Flower Power

277 Mona Vale Road, Terrey
Hills

Final v1.0

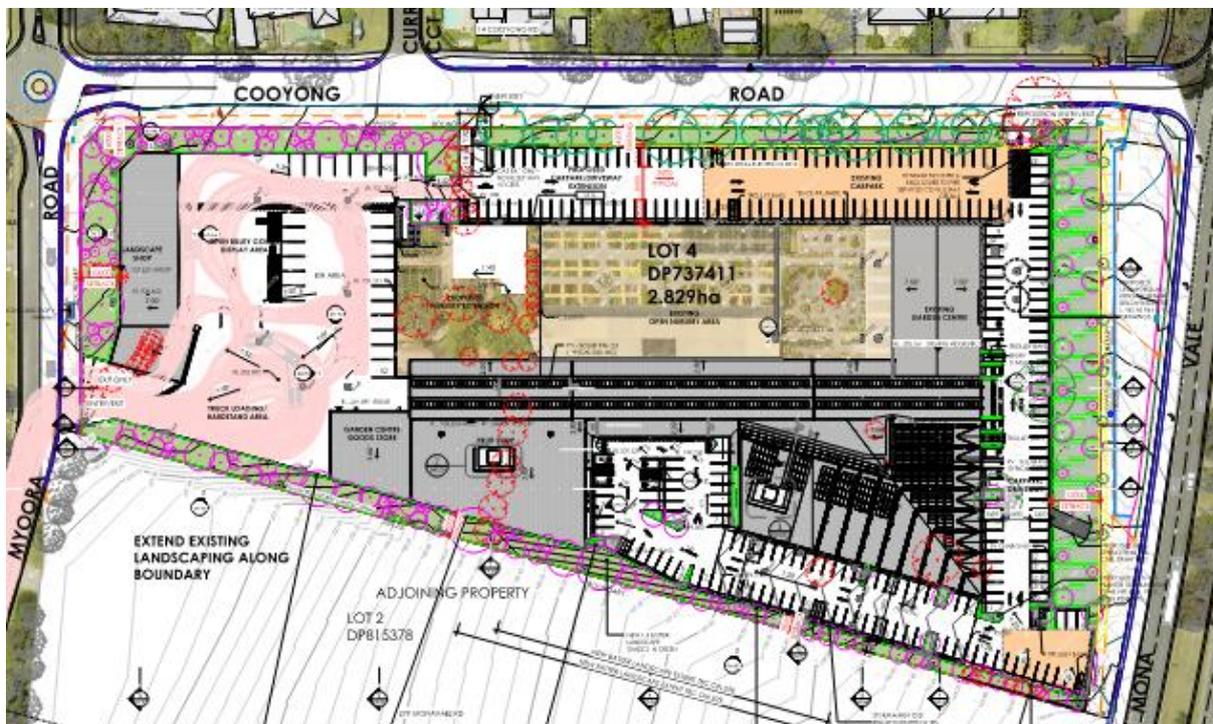
MGAC has reviewed the drawings and documentation in relation to the aforementioned requirements. An accessible path of travel has been provided from the site boundary to the building entry (refer part site plan below). Further work will be required during design development stage to ensure appropriate outcomes are achieved.
